Access Compliance Report

Public Rights-of-Way

(Curb Ramps)

Intersection ID: 24149	Main Street: CAROWINDS_BV	Cross Street: SOUTH_POINT_BV	Location: NW
ADA ID: BAC7991DD316	Ramp Type: Perp	Initial Pass/Fail: Fail	Overall Compliance: No
Severity Score: 12.5			
Codes/Mitigation Info/Possible Solution		Field Measurements/Component Compliance

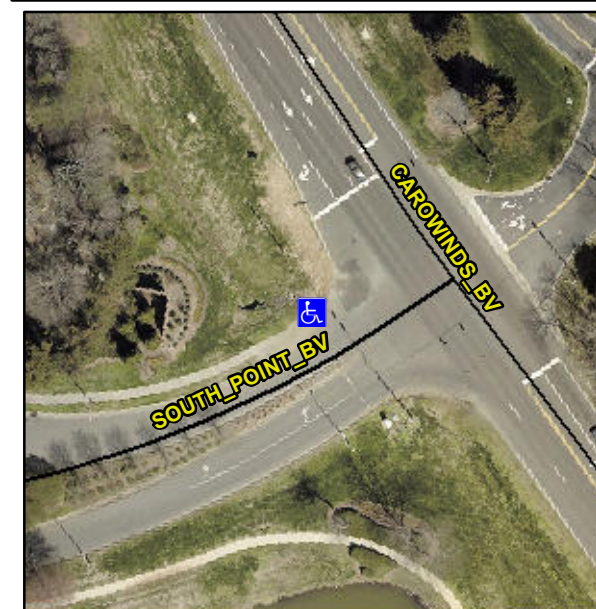
R304.2.2

Compliance	Description	Data	Compliance	Description	Data
N/A	Ramp Length (in)	47.5	No	Ramp Slope (%)	11.1
Yes	Ramp Width (in)	48.0	Yes	Ramp XSlope (%)	1.2
N/A	Flare Type LT	N/A	N/A	Flare Type RT	N/A
N/A	Flare Slope LT (%)	N/A	N/A	Flare Slope RT (%)	N/A
N/A	Flare Traversable LT?	N/A	N/A	Flare Traversable RT?	N/A
N/A	Landing Length (in)	N/A	N/A	DWS Provided?	N/A
N/A	Landing Width (in)	N/A	N/A	DWS Contrast?	N/A
N/A	Landing Slope (%)	N/A	N/A	DWS Length (in)	N/A
N/A	Landing X Slope (%)	N/A	N/A	DWS Full Width?	N/A
N/A	Landing Curb? (Y/N)	N/A	N/A	DWS Offset (in)	N/A
N/A	Shared Landing?	N/A			
N/A	Gutter Ponding?	N/A	N/A	Gutter Slope (%)	N/A
N/A	Gutter Lip Ht (in)	N/A	N/A	Gutter X Slope (%)	N/A
N/A	Painted X Walk1?	No	N/A	Painted X Walk2?	N/A
	X Walk 1 Direction	To S		X Walk 2 Direction	N/A
N/A	X Walk 1 Width (in)	N/A	N/A	X Walk 2 Width (in)	N/A
	X Walk 1 Slope (%)	5.4		X Walk 2 Slope (%)	N/A
	X Walk 1 X Slope (%)	1.3		X Walk 2 X Slope (%)	N/A

Remove & Replace Entire Ramp.
